## Technical Service Bulletin (TSB)

### Turbocharger Wire Harness Connector Interference

<b>REFERENCE:</b>	<b>TSB:</b> 09-001-25 <b>GROUP:</b> 09 - Engine	<b>Date:</b>	January 18, 2025	<b>REVISION:</b>	—
<b>VEHICLES AFFECTED:</b>	<b>2024 - 2025 (H1) Jeep Commander</b> <b>2024 - 2025 (M1) Jeep Compass</b> This bulletin applies to H1 vehicles built on and before January 09, 2024 (MDH 0109XX) and on or before December 17, 2024 (MDH 1217XX). This bulletin applies to M1 vehicles built on and before January 04, 2024 (MDH 0104XX) and on or before December 17, 2024 (MDH 1217XX).			<b>MARKET APPLICABILITY:</b>	
				<input type="checkbox"/> NA	<input type="checkbox"/> MEA
				<input type="checkbox"/> EE	<input type="checkbox"/> IAP
				<input checked="" type="checkbox"/> SA	<input type="checkbox"/> CH
<b>CUSTOMER SYMPTOM:</b>	Customers may experience a Malfunction Indicator Lamp (MIL) illumination and the vehicle may exhibit/set the following Diagnostic Trouble Code (DTC): <ul style="list-style-type: none"> <li>• P012D-00 - Turbocharger/Supercharger Partida A Frio - Controle "A" - Circuito Alto.</li> </ul> Customers may also experience the following: <ul style="list-style-type: none"> <li>

**Fig. 1**  
Inspection Location

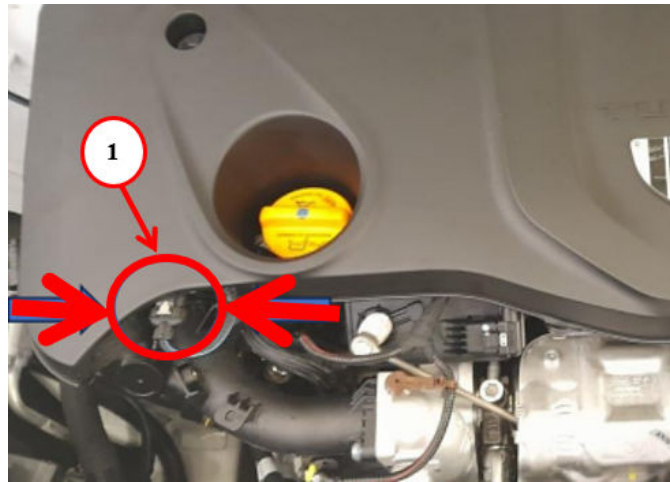
1. Open the hood.
2. Locate the turbocharger wire harness connector inspection area [Fig. 1](#).

1 - Turbocharger Wire Harness Connector

**Fig. 2**  
Turbocharger Wire Harness Connector

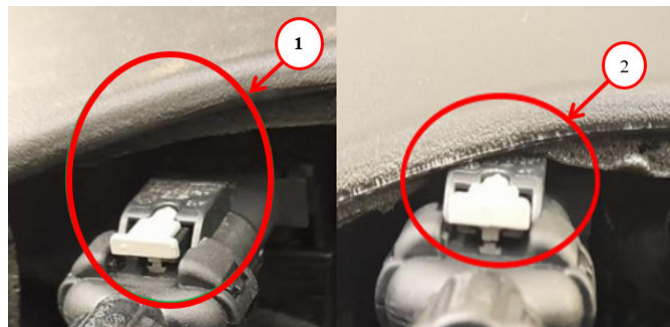
3. Inspect the turbocharger wire harness connector for interference with the engine beauty cover [Fig. 2](#).

1 - Correctly Installed Air Cleaner Housing Causing No Interference

2 - Incorrectly Installed Air Cleaner Housing Causing Interference

4. Is the turbocharger wire harness connector interfered with by the engine beauty cover?
  - YES>>> Proceed to [Step 5](#).
  - NO>>> This bulletin has been completed. Use Inspection LOP (14-10-01-97) to close the active RSU.

5. Remove and install the engine air cleaner assembly. Refer to the detailed service procedures available in DealerCONNECT/Service Library under: Service Info> Motor / 1048A10 - Filtro de ar completo - remocao/ recolocacao. incluso procedimientos necesarios.

**Fig. 3**  
**Engine Air Cleaner Installation**

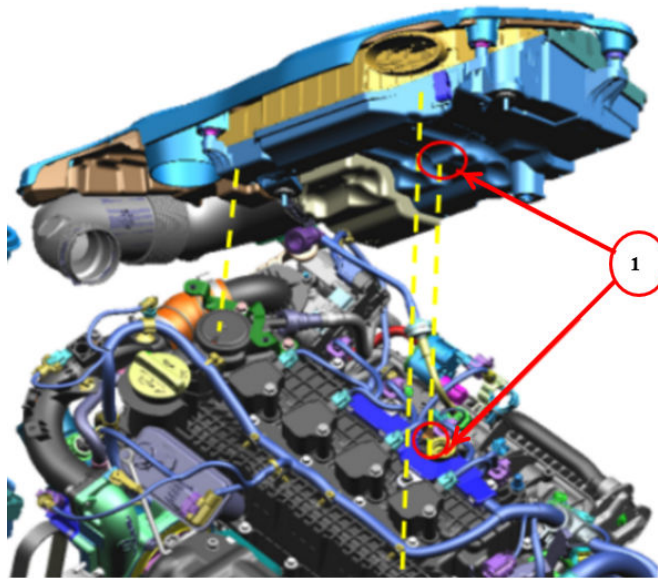
**NOTE: When installing the engine air filter assembly, make sure that the connection in Fig. 3 is made. This will prevent the harness interference from occurring.**

1 - Correct Engine Air Filter Assembly Installation Orientation
